<b>ADDENDUM TO THE CONTRACT DOCUMENTS</b>	<b>Page Number</b> 1	<b>No. of Pages</b> 12
<b>Addendum No. One</b>	<b>Date Addendum Issued:</b> 6 March, 2015	
<b>Issuing Office</b> Dept. of Natural Resources-Procurement Officer 550 West 7 <sup>th</sup> Avenue, Suite 1230 Anchorage, Alaska 99501 Phone: (907) 269-8666 Fax: (907) 269-8909	<b>Previous Addenda Issued</b> None	
<b>Project:</b> Copper River Fire Facility <b>Project No.:</b> 32034-1	<b>Date &amp; Hour of Quotes Due:</b> Revised: Friday, March 27, 2015 at 2:00 PM Alaska time

**Copper River Fire Facility, Project No. 32034-1**

ADDENDUM NO. 1                      MARCH 6, 2015

PROJECT:                                    COPPER RIVER FIRE FACILITY

1 STAIR SECTION - 9/A303  
A01 1" = 1'-0"

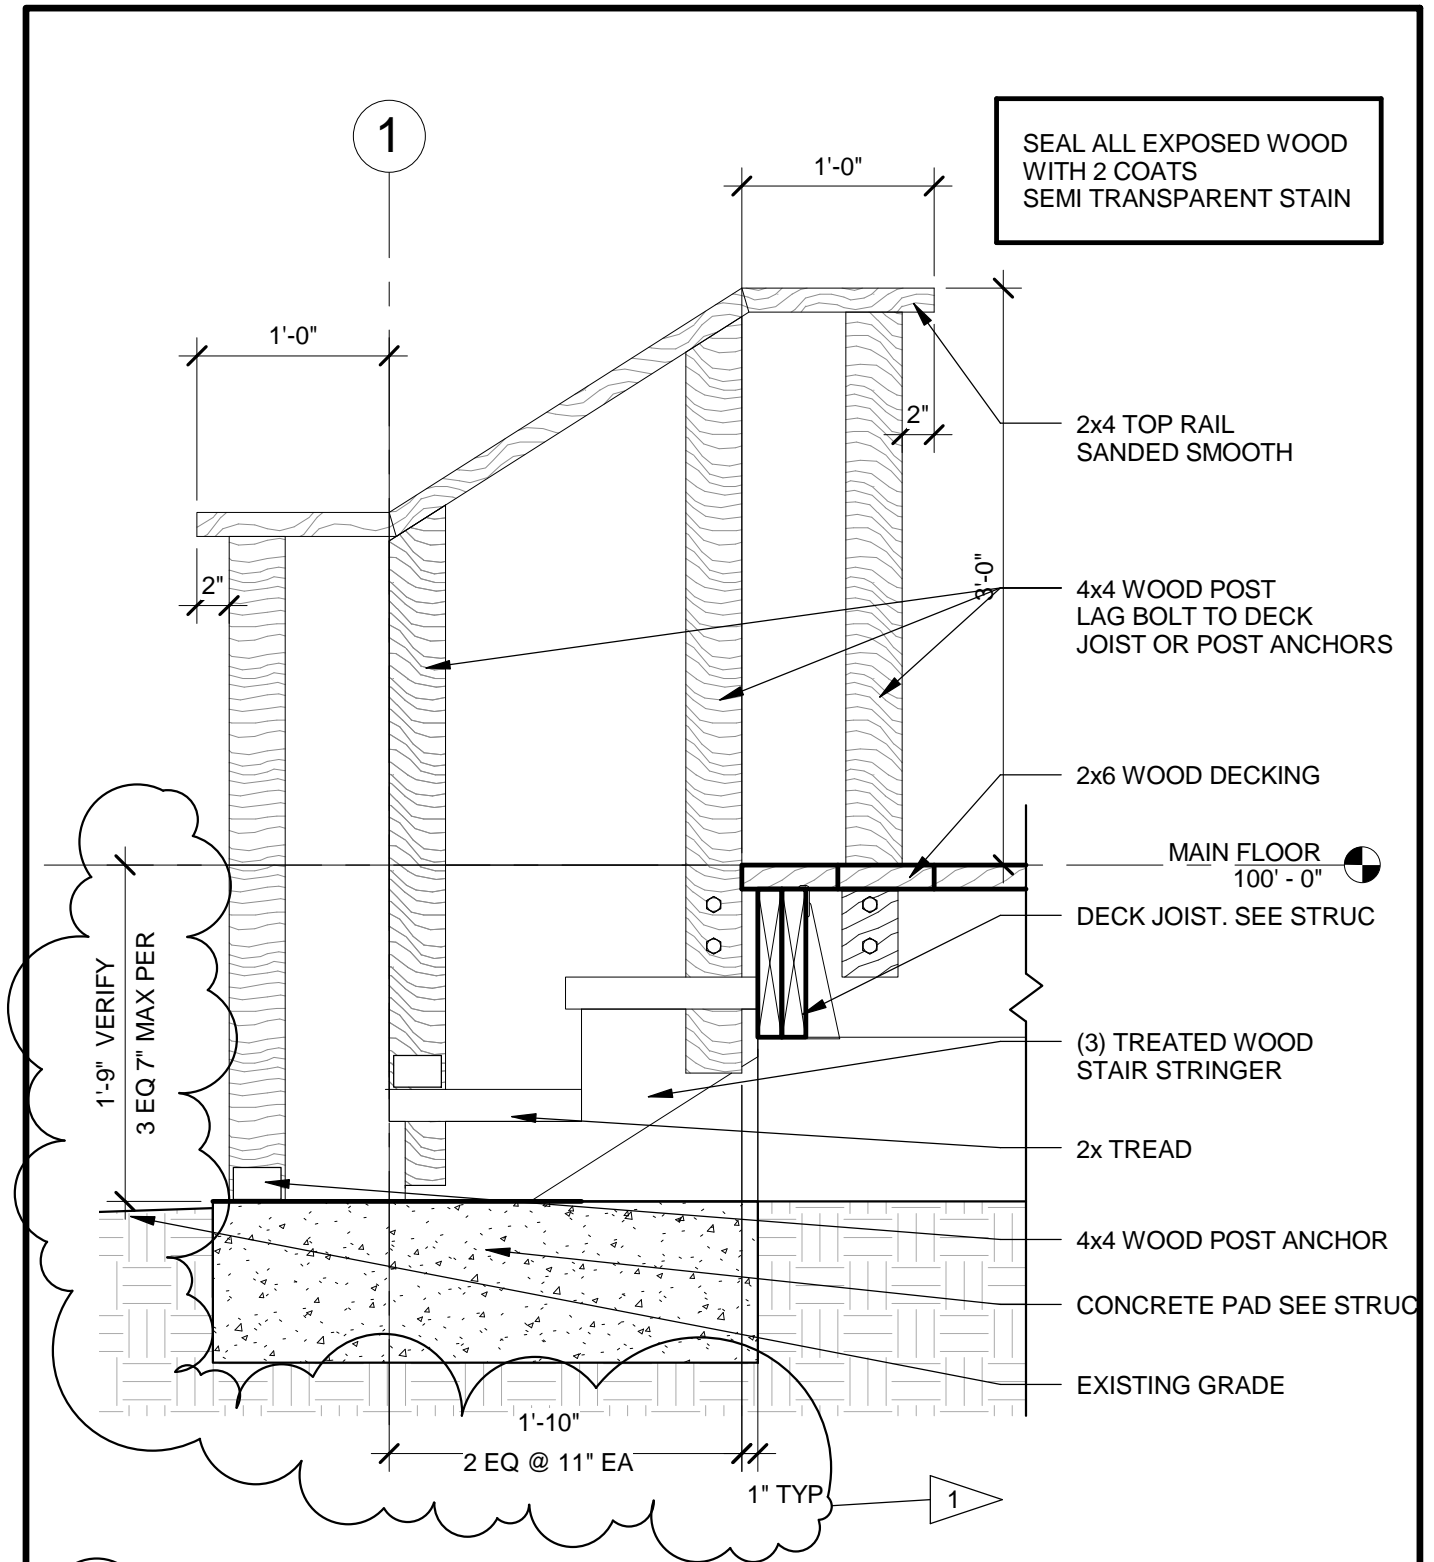
**3. SHEET A303:**

**CHANGE:** Added clarity to rise and run dimension strings, confirm with existing grades. Detail 9/A303 Stair Section.

1  
A02  
MAIN FLOOR CODE PLAN - 1/G101  
1/8" = 1'-0"

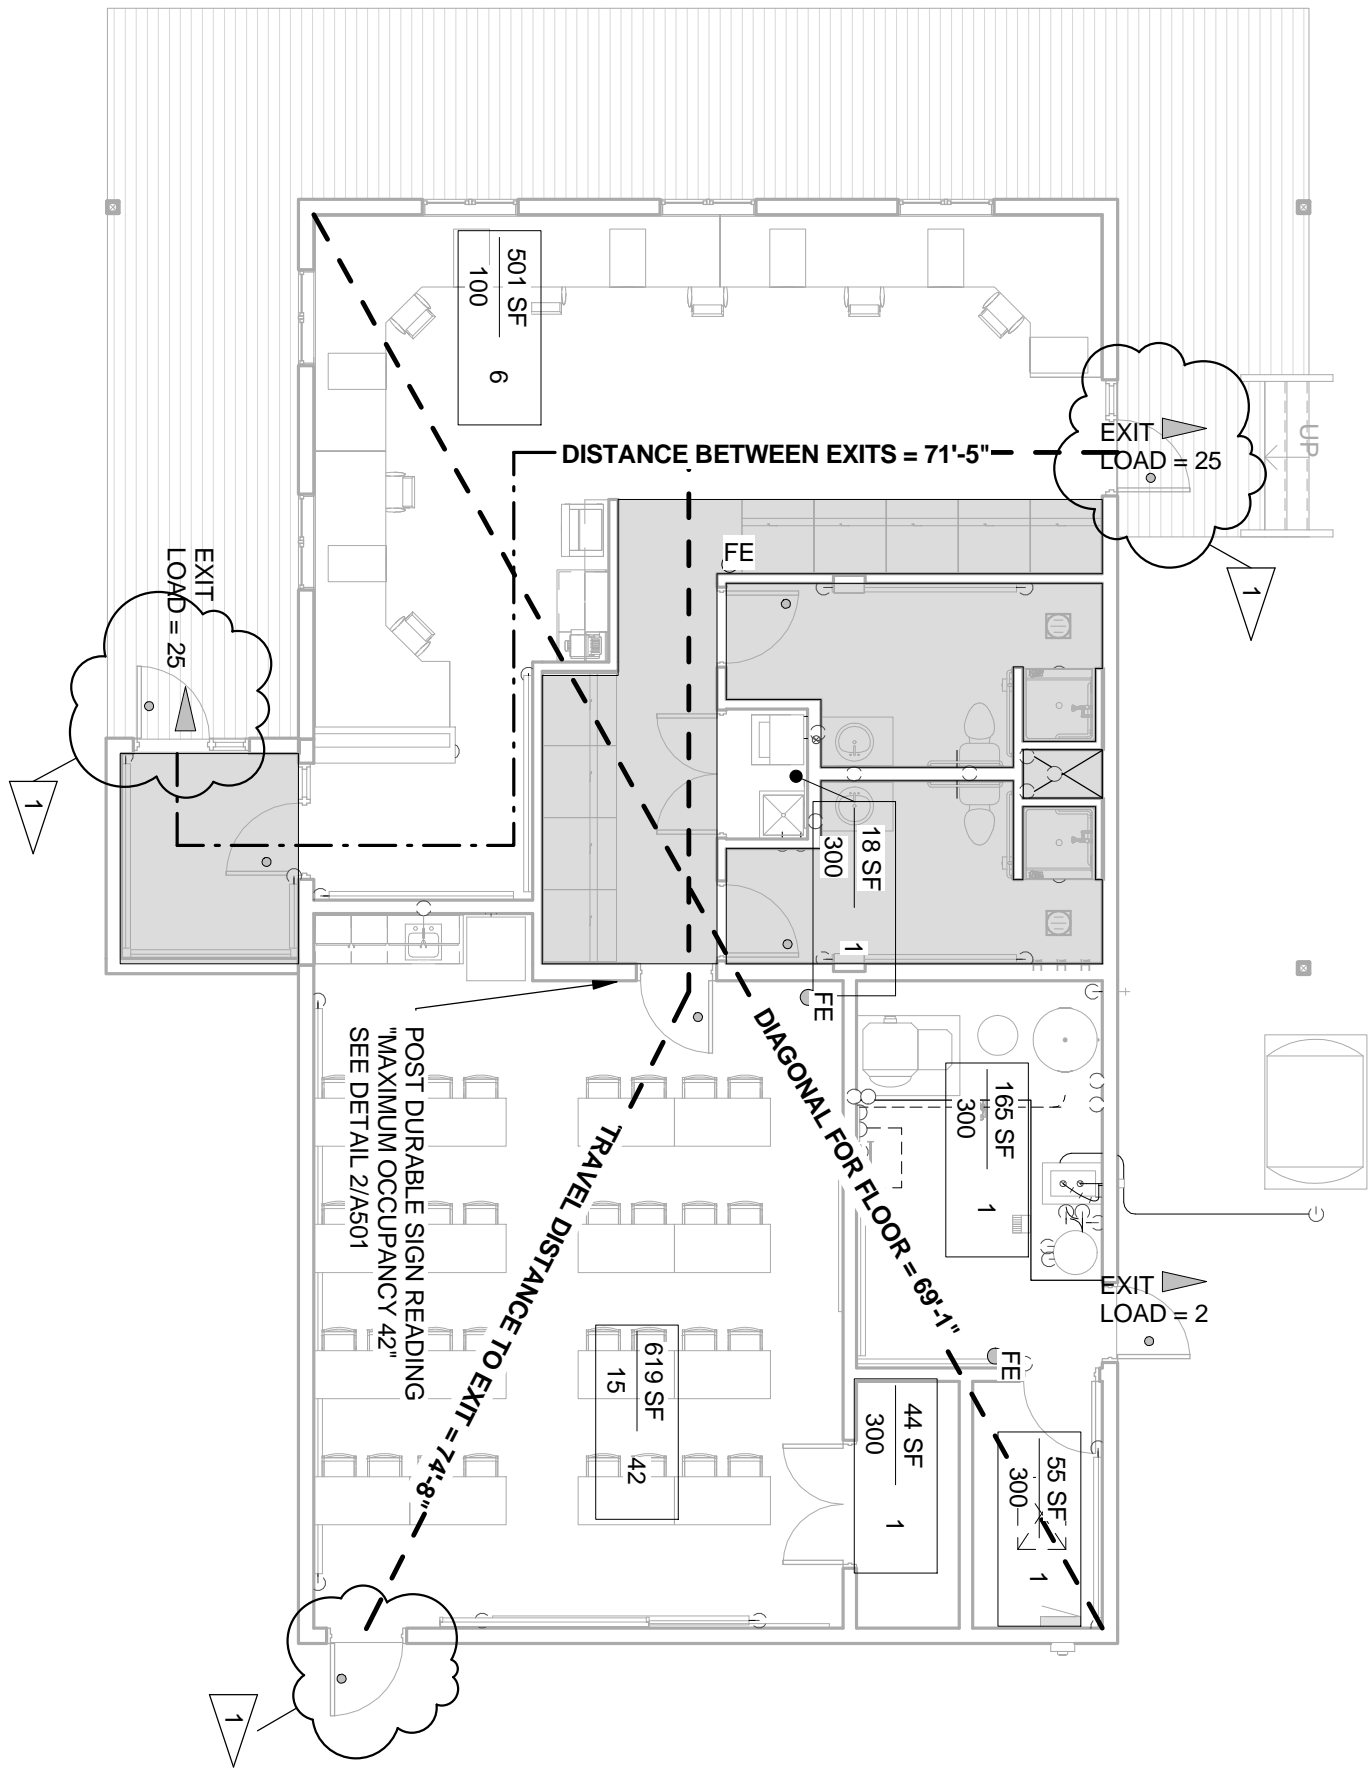
**1. SHEET G101:**

**CHANGE:** DOOR 107-2 located in TRAINING 107 to no longer serve as an emergency exit. Exit load directed out of doors 103-1 & 101-1.
